ADDENDUM NO. 2

01-11-2024

Porterville College Sports Complex (PC Baseball/ Softball Field)
100 E College Ave,
Porterville, CA 93257

DARDEN PROJECT NO. 2118
DSA File Nos. 03-122694
DSA APPL. NO. 15-C1

Designed By:	Copyright	Darden Architects
Scale: 1" = 20'-0"	Drawn By:	AD2-LX-02	
Project Number: 2118	Checked By:	SD/L300	
Date: 05-10-23	Reviewed By:	AD2-LX-02

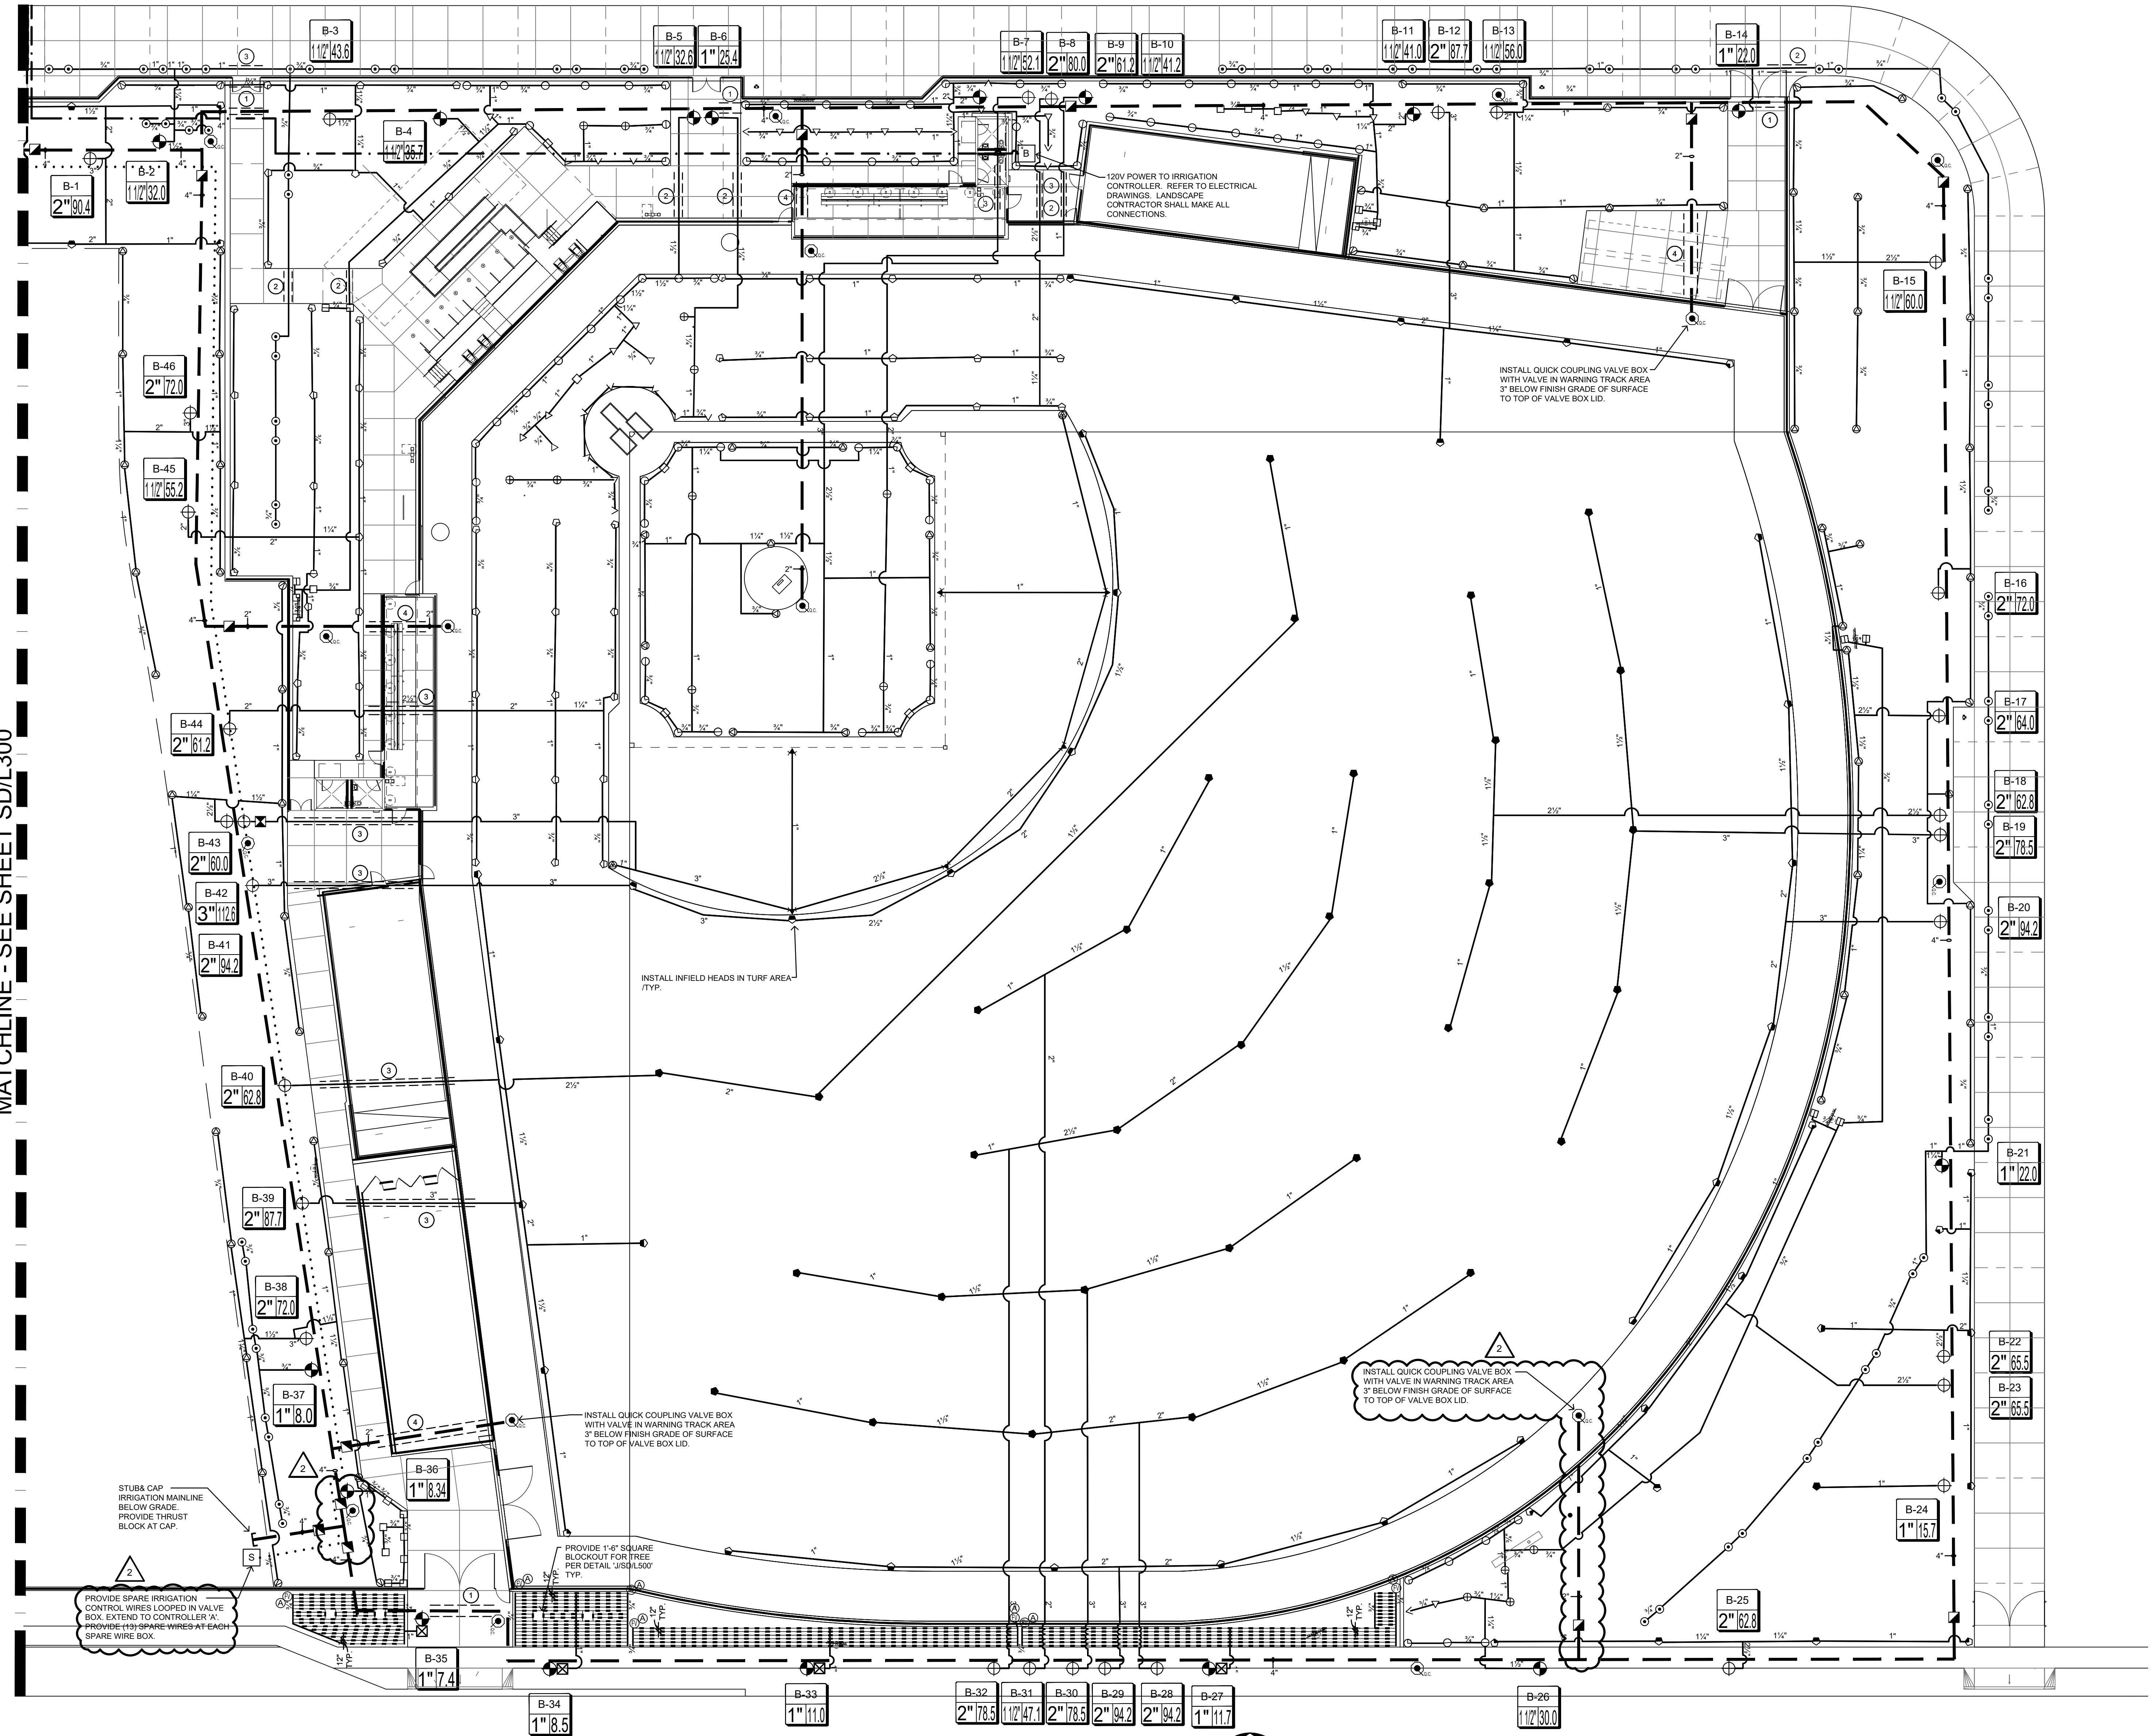
AD2-L02 Refer to Sheet SD/L300 and Attached Sheet AD2-LX-02 dated January 10, 2024

1. Replace Sheet SD/L300 with the attached Sheet AD2-LX-02
2. Revised text to clarify pipe sizes and revised text at infield quick coupling valve. Refer to attached drawing AD2-LX-02, dated January 10, 2024..

Scale: 1" = 20'-0"	Designed By:	Copyright: Darden Architects
Project Number: 2118	Drawn By:	AD2-LX-03
Date: 05-10-23	Checked By:	SD/L301
	Reviewed By:	AD2-LX-03

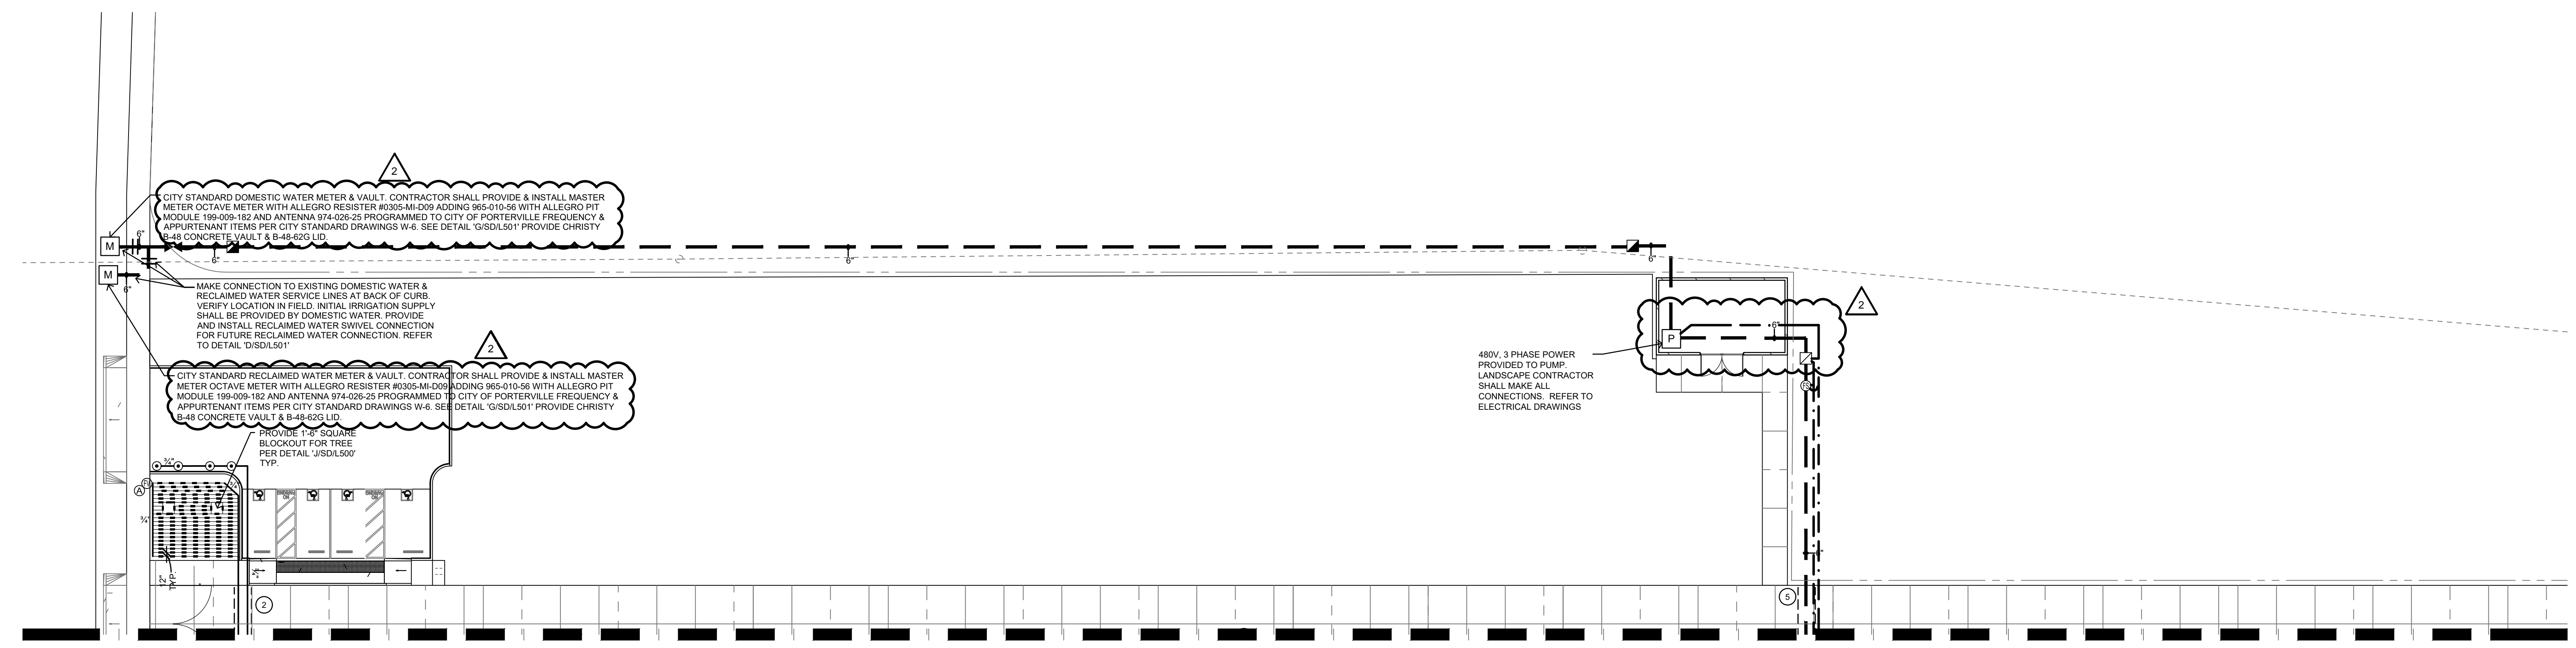
AD2-L03 Refer to Sheet SD/L301 and Attached Sheet AD2-LX-03 dated January 10, 2024

1. Replace Sheet SD/L301 with the attached Sheet AD2-LX-03
2. Revised text to clarify pipe sizes and added irrigation gate valves, mainline and quick coupling valve.

G CITY STANDARD WATER CONNECTION

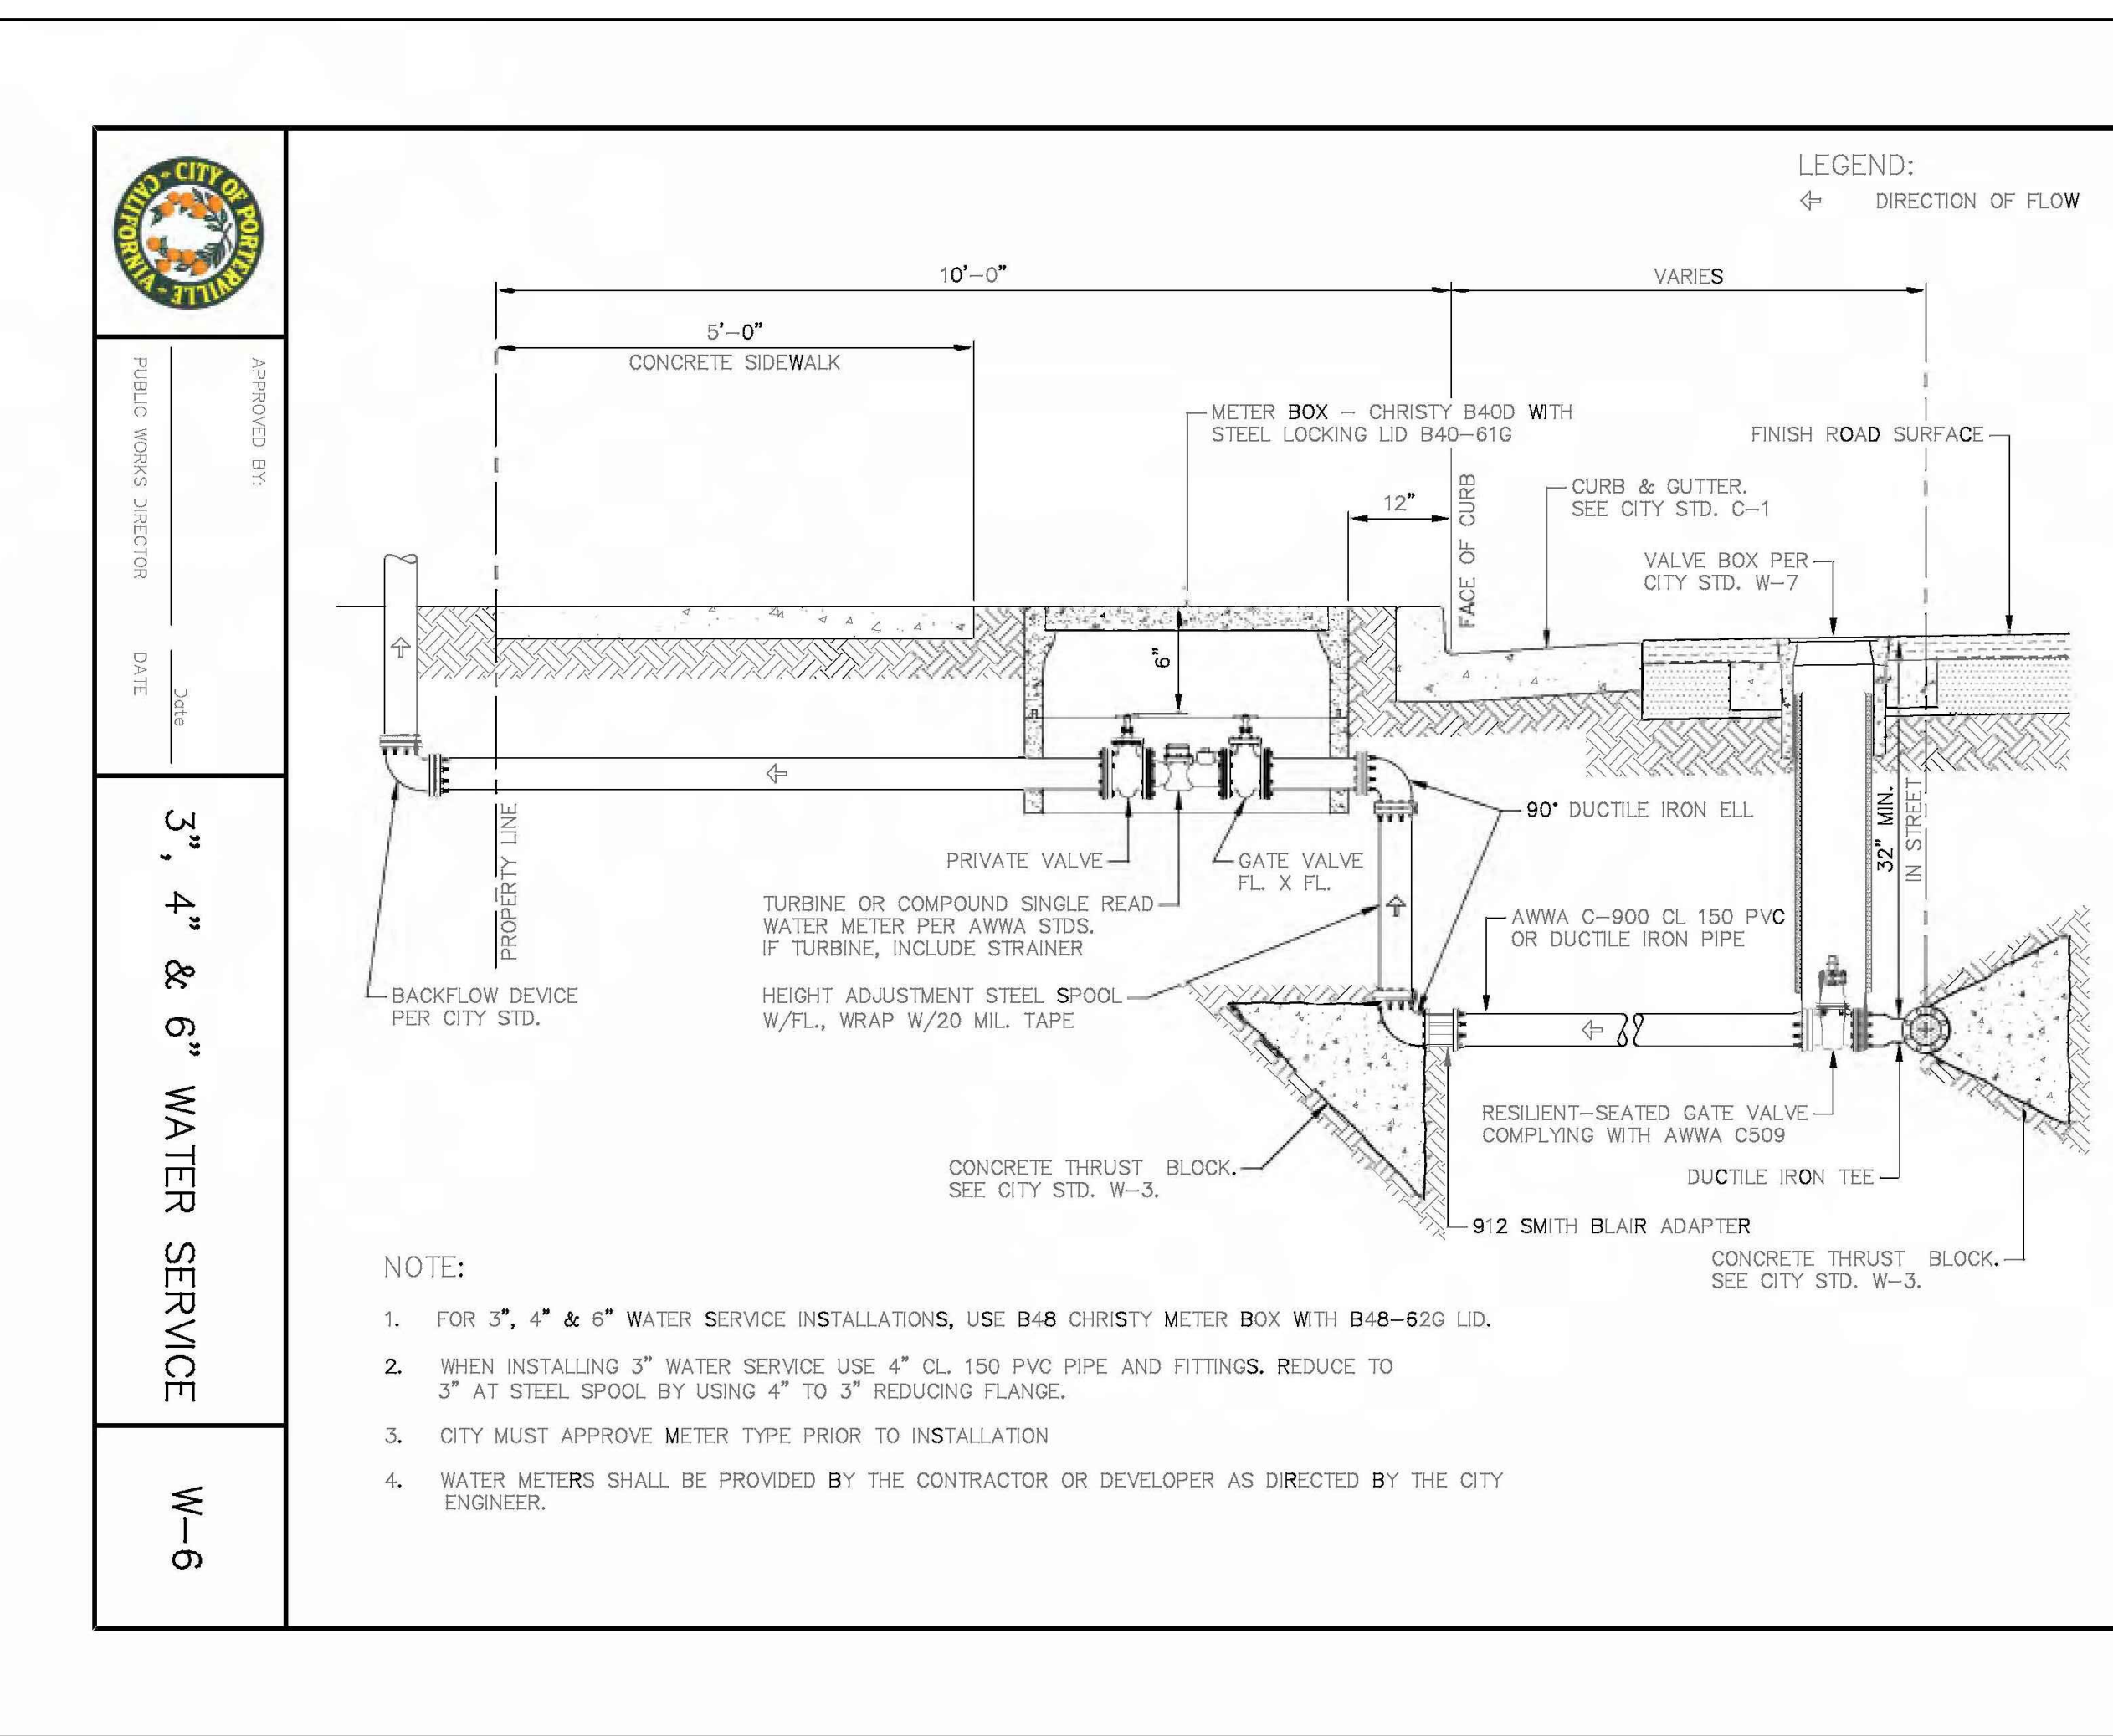
1. Replace Sheet SD/L501 with the attached Sheet AD2-LX-06
2. Refer to Planting Details, Detail 'D/SD/L501. Revised text for clarity. Added painting requirement for reclaimed water pipe above grade.
3. Refer to Planting Details, F/SD/L501. Revised compacted subgrade to 95% relative density for compaction under mowstrip.
4. Refer to Planting Details, G/SD/L501. Added City of Porterville Water Connection, Detail G/SDL501.
